Re: Reg No. W0032-03 – Notice in Accordance with Article 14 (2) b (ii) of the Waste Management (Licensing) Regulations

Application by Waterford County Council for Waste Licence Application
W0032-03 for Dungarvan Landfill, County Waterford

Replies to Request for further information in
accordance with Article 14(2)(b)(ii) of the Waste
Management Regulations

Dungarvan Landfill Waste Licence Application Article 14 Response

Drawing Number: **MDR0350/DG0706**

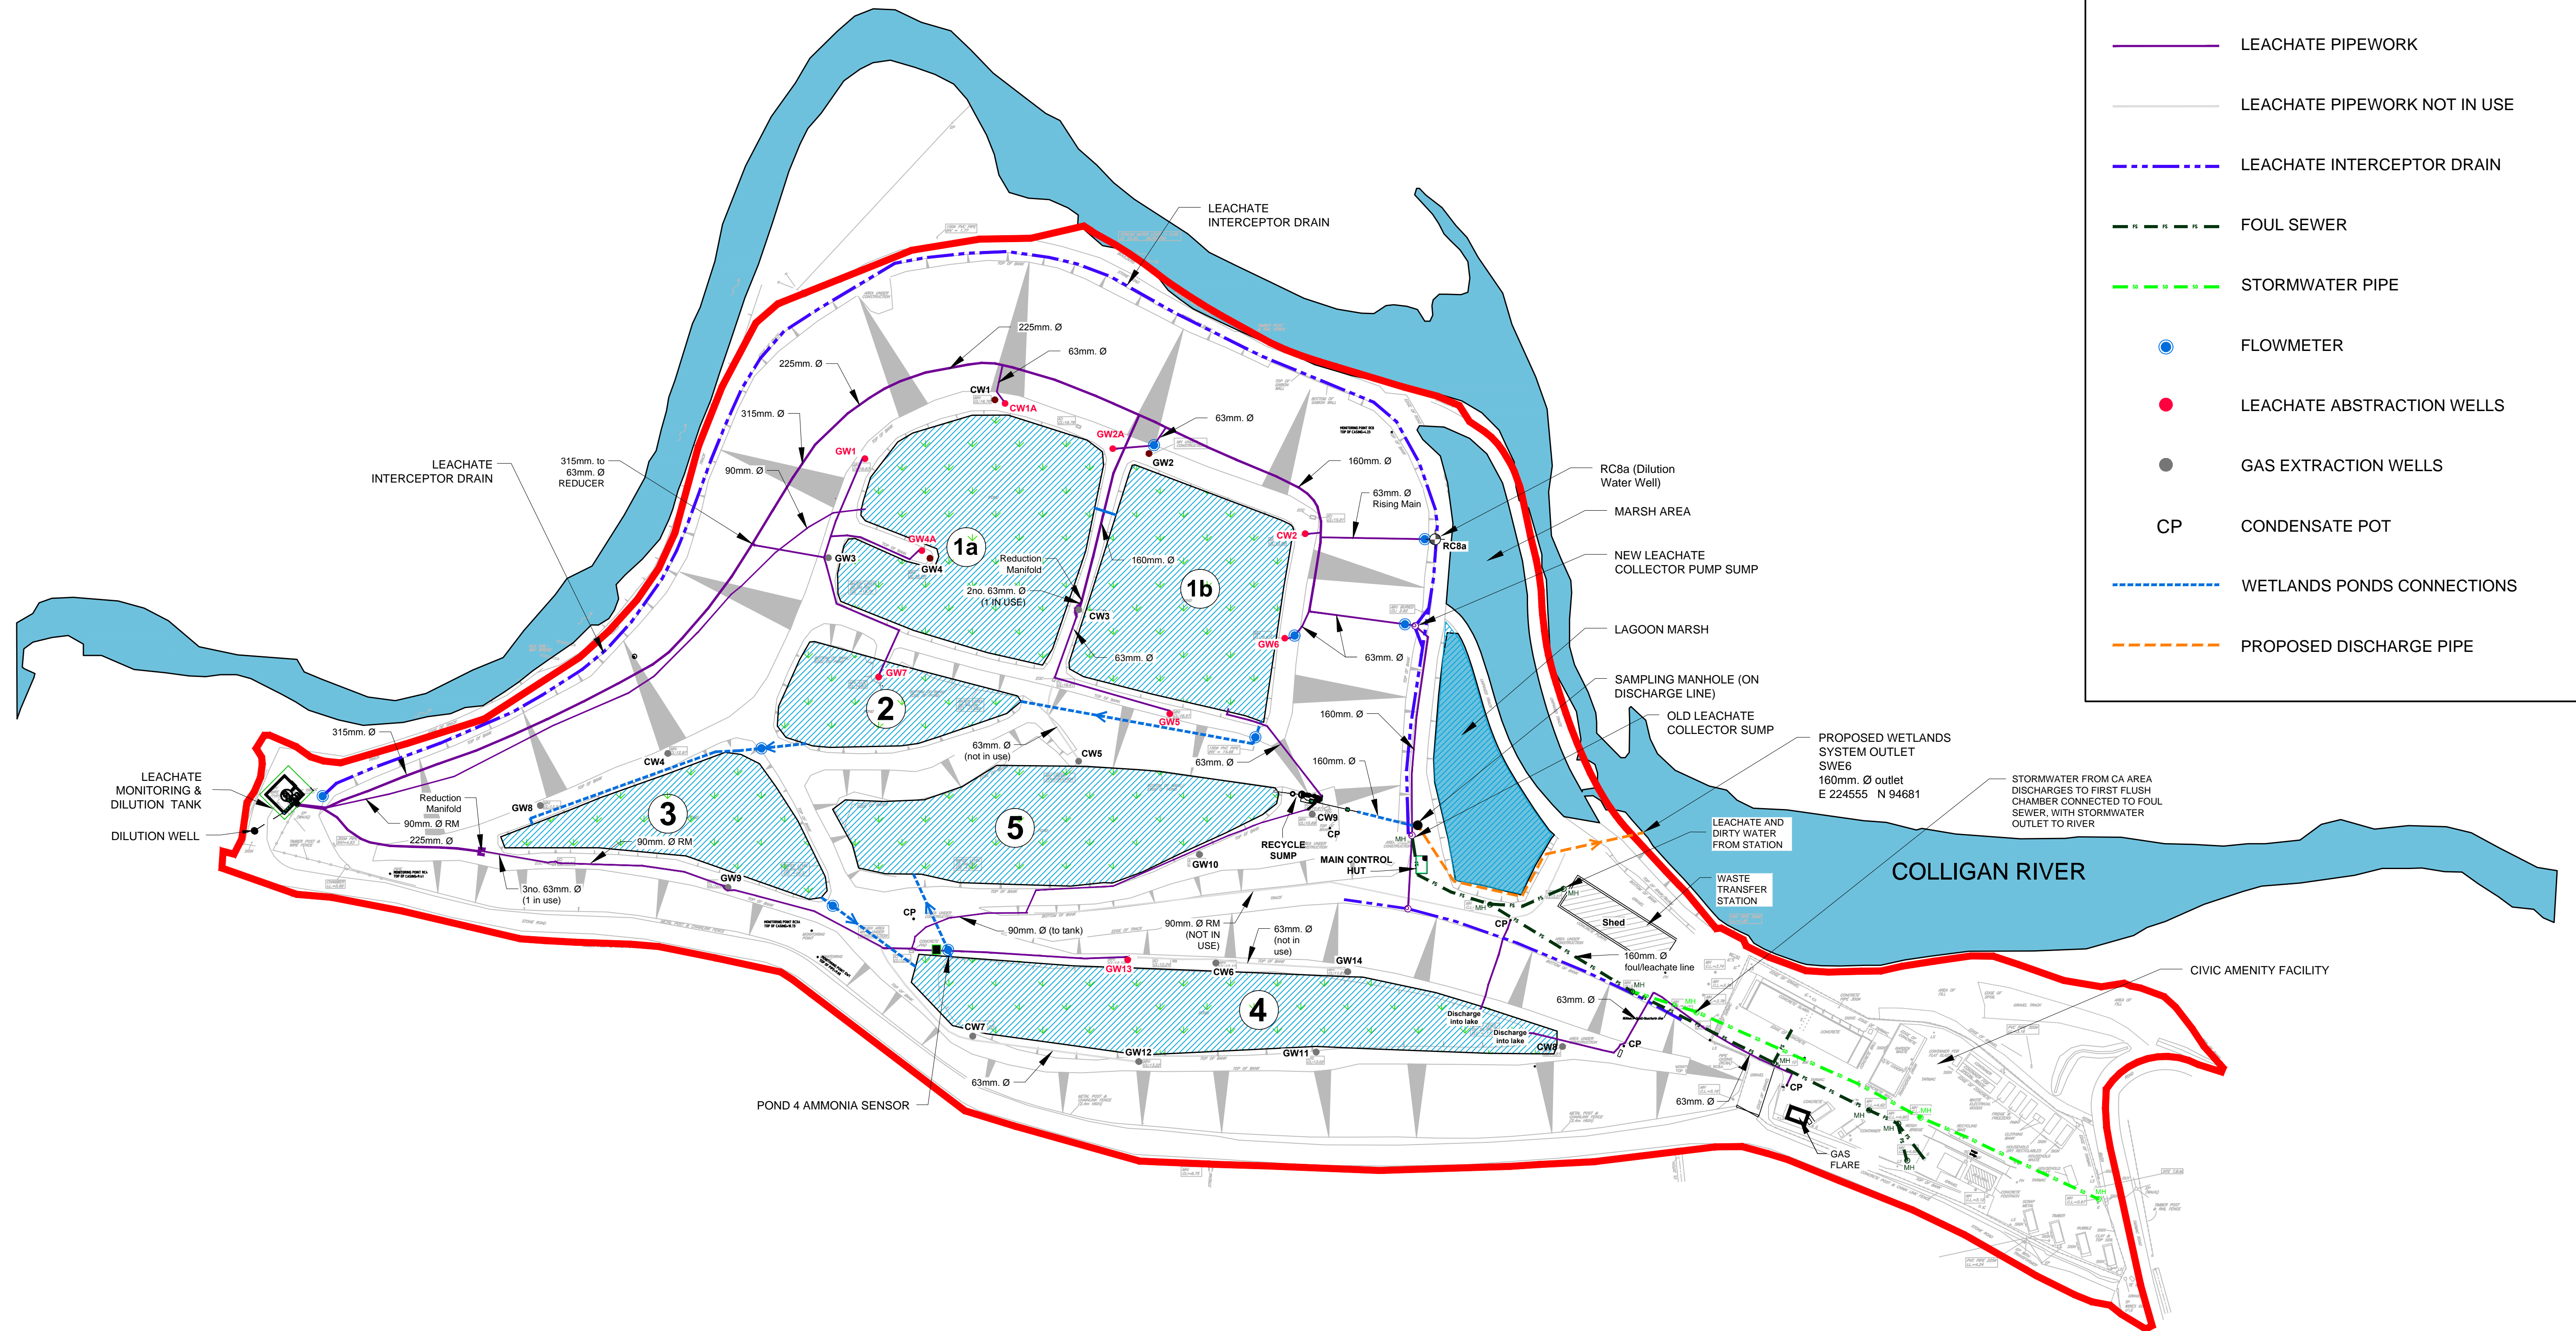
State why, instead of the current arrangement, the discharge from SWE6 is not piped directly to the river from SWE6.

It is now proposed to alter the existing discharge arrangement and to discharge directly from the last sampling manhole to the Colligan River as outlined in the revised drawing MDR0350DG0706R03 which is included in Appendix 3.
